| TITLE | | | + 10 VOLT POWER SUPPLIES | | PIB NO. DK3001A |
| PRODUCT LINE | TAPE DISK FORMATTER | <input checked="" type="checkbox"/> | EQUIPMENT CHANGED SERVO PCBA 102811-XX | MODEL SERIES AFFECTED D-3000 | EFFECTIVE DATE 6-18-74 |

NOTE:
 PRODUCT IMPROVEMENT BULLETIN DK3001A REPLACES
 PIB DK3001 IN ITS ENTIRETY. REMOVE AND DESTROY
 PIB DK3001.

SUBJECT: + 10 VOLT POWER SUPPLIES

FIGURE I

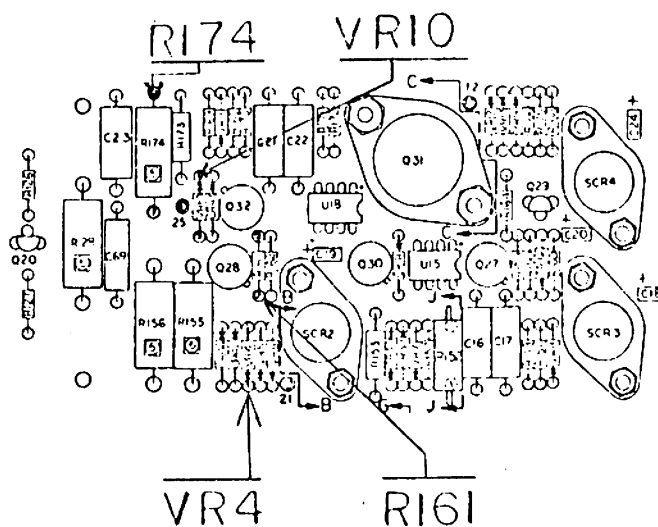
- VR4, VR10, R161 and R174 are power supply components that regulate the (+) and (-) ten (10) volt supplies. VR4 and VR10 are one (1) watt zeners currently being operated at approximately 800 mw by R161 and R174. By changing the above-mentioned components, VR4 and VR10's wattage factor will decrease to approximately 500mw.

- Rework instructions are as follows (See Figure 1).
- Replace VR4 and VR10 noting the cathode and anode positions.
- Replace R161 and R174.
- Readjustment of +5V and -5V is required as per D3000 Manual, Page 6-14, Section, 6.6.1.

| Zone | Component | From | To |
|------|-----------|----------|----------|
| 15-F | VR4 | 330-1005 | 330-1001 |
| 15-F | R161 | 27 Ohms | 39 Ohms |
| 15-E | VR10 | 330-1005 | 330-1001 |
| 15-D | R174 | 220 Ohms | 330 Ohms |
